Town & Country Planning Act 1990 47 Doughty Street, London WC1N 2LW (Application Reference 2016/1027/P)

Thank you for your email of 19 April 2016 identifying a number of areas for us to respond to. This letter provides our client's response to your comments which I set out below.

Photo of existing rear basement room former fireplace

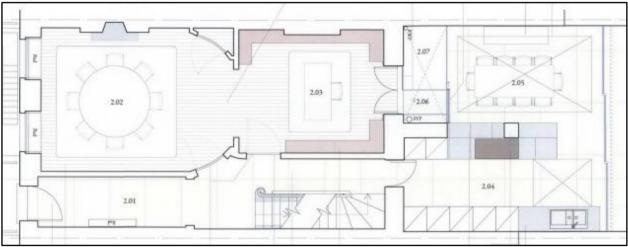
2. At basement level it is proposed to reconfigure the shape of the internal bathroom in the rear room. Although, there are no issues with retaining a bathroom in this space, it is not acceptable to increase the width of this enclosure so that its southern wall coincides with the chimney breast in this room. It is advised, therefore, that the bathroom enclosure is retained in its current form.

We acknowledge this comment but the chimney breast and fireplace has been previously substantially altered to form a large cupboard which may not be evident from the drawings. The photo below shows the existing configuration.

Given that the original fabric has been removed and the existing non original enclosure that forms the bathroom we feel that making the bathroom larger would have no greater impact on the original fabric or layout of the listed building than currently exists. It is merely an alternative location for a dividing wall that already exists. If the fireplace was in place and had not been altered we would fully agree with the Council's comments and would not have proposed the layout we have. We hope the photograph helps explains our design rationale.
